Lower Thames Crossing

Thurrock Council Comments on Applicant's Submissions at Deadline 3 (D3)

19 September 2023

Figure 10-1: UC11 delivery HGV construction traffic routing Phase 5 AM Peak

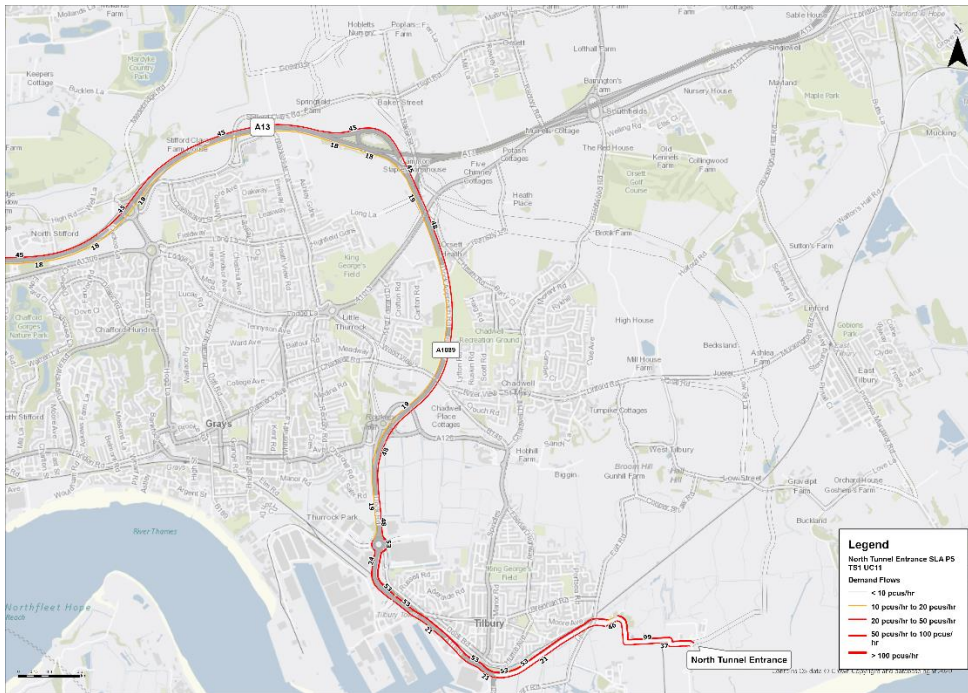
- 10.3.9 **Figure 10-1** below shows that the two-way flow into and from the Northern Tunnel Entrance compound, generated only by the LTC project, is predicted to be 136 pcus/hour of which 99 pcus/hour are destined for the compound and 37 originate from the compound. It can be seen that, as expected, the majority of trips destined for the compound (48 pcus/hour) use the A1089 and also pass through the ASDA roundabout, while 24 pcus/hour originating from the compound pass through the ASDA roundabout and use the A1089. This assumes a significant proportion of construction related traffic has its origin and destination within the Port of Tilbury, which could under-estimate the quantum of HGVs passing through the ASDA roundabout considering the applicant's limited commitment to use marine or rail transport for tunnelling operations.

Figure 11.1: Schematic of potential differences in traffic growth between 2030 and 2032

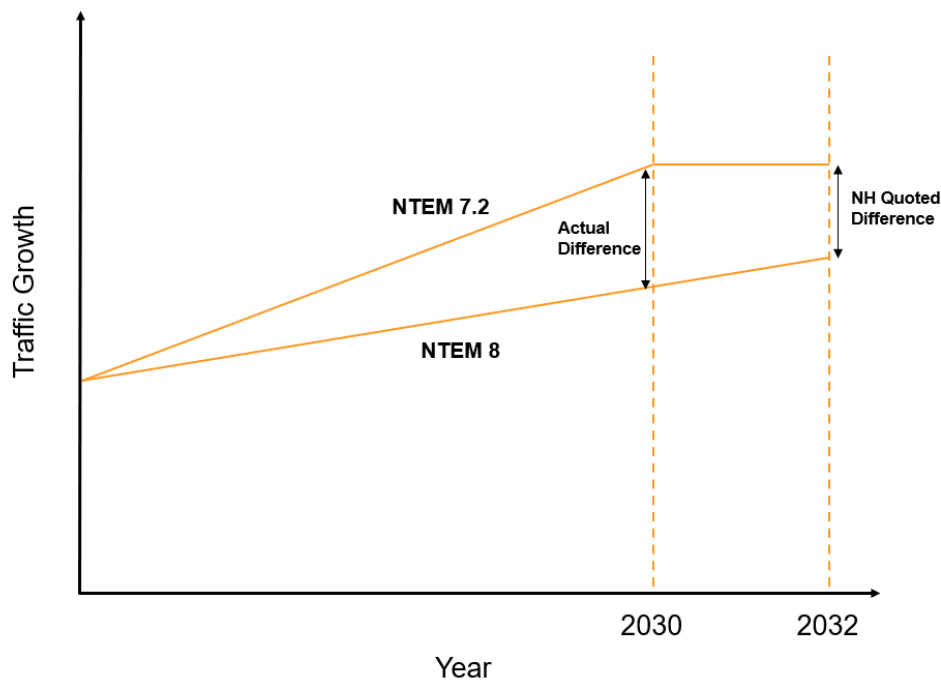
- 11.2.9 The Council notes presenting traffic flows in 2032 allows the applicant to claim two years of 'free' background growth compared to 2030. Including this growth will reduce the difference between the traffic flows in 2030 and 2032. Figure 11.1 provides a schematic representation of the potential differences between 2030 and 2032 flows.

Table 3.1: ASDA Base Year Microsimulation Model RAG Review

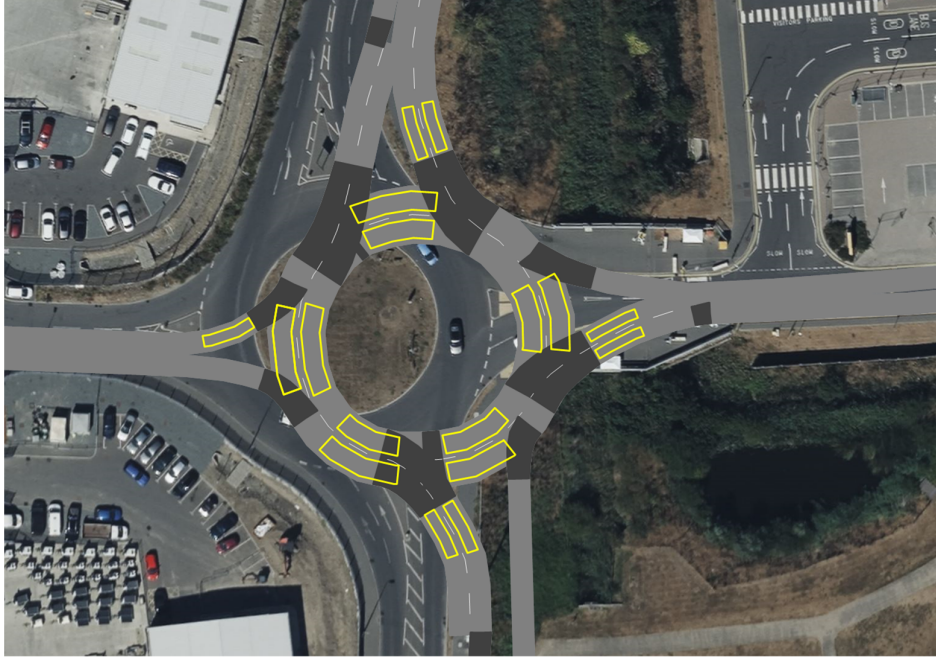
- 3.1. A review of the Base Model has been undertaken and Table 3.1 identifies the following elements that require further investigation.

Nr	Network Objects	Issue	RAG
1	Scenario management	The base year model was calibrated and validated for the AM and PM peak periods. PTV VISSIM 2020 software version was used to develop the models, but the scenario manager function of the software was not used, which would keep the differences between the models at minimum. It is requested to bring the model under scenario management, which would control discrepancies between the AM and PM model and would ensure that forecast and future scenario models are developed quicker without differences in the AM and PM models.	Red
2	Model network placement	The models were created using CAD background mapping, and it is noted that the network does not line up with the software built in map. While this is not an issue, it was found that the AM and PM models are at different locations, and the AM model seems to be 35 metres offset, and both models are inaccurately rotated (to background mapping).	Green

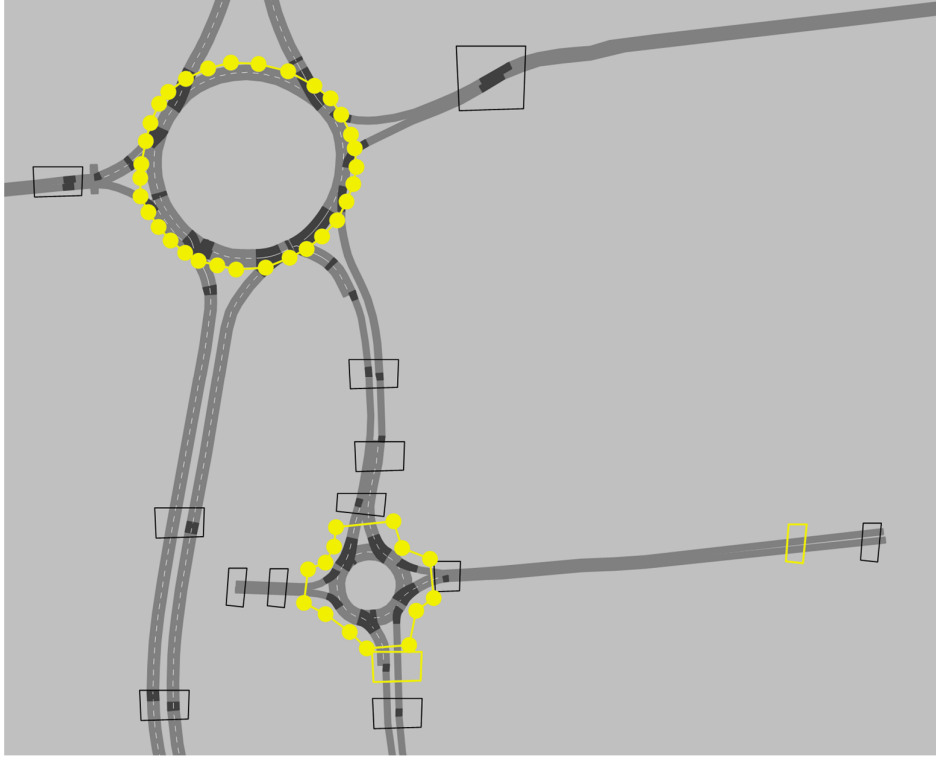
Nr	Network Objects	Issue	RAG
12	Reduced speed areas	In the AM model reduced speed areas 91 and 92 assign speeds for vehicle type 51 (cars) and not to vehicle 10 (cars). Veh type 51 is not assigned to any vehicle compositions or matrices (not in use).	
13	Reduced speed areas	Reduced speed area is missing on A1089 SB, s/o ASDA roundabout (link 7).	
14	Reduced speed areas	<p>Reduced Speed Areas should be coded on the westbound, south-westbound and southbound exits of the ASDA roundabout.</p> 	
15	Reduced speed areas	Reduced speed areas should be coded on all exits of the Amazon warehouse access roundabout.

Nr	Network Objects	Issue	RAG

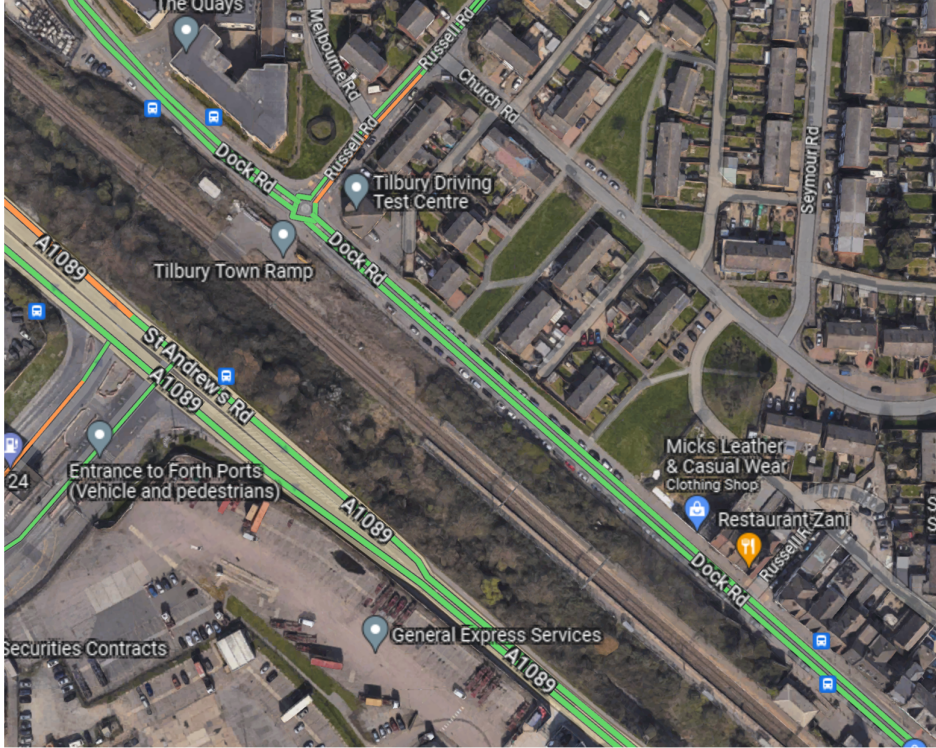
16	Reduced speed areas	<p>It is good practice to consider that buses and HGVs navigates bends and roundabouts with a slower speed than cars and LGVs. This is not considered in the model and vehicles are assigned the same speed on bends regardless of the vehicle type – see example below.</p> <div data-bbox="483 1167 1073 1633" style="border: 1px solid gray; padding: 5px;"> <p>Reduced Speed Area ? x</p> <p>No.: <input type="text" value="71"/> Name: <input type="text"/></p> <p>Link - lane: <input type="text" value="19 - 1"/></p> <p>Length: <input type="text" value="5.000 m"/> Time From: <input type="text" value="0 s"/></p> <p>At: <input type="text" value="5.290 m"/> until <input type="text" value="MAX"/></p> <p><input checked="" type="checkbox"/> Show label</p>
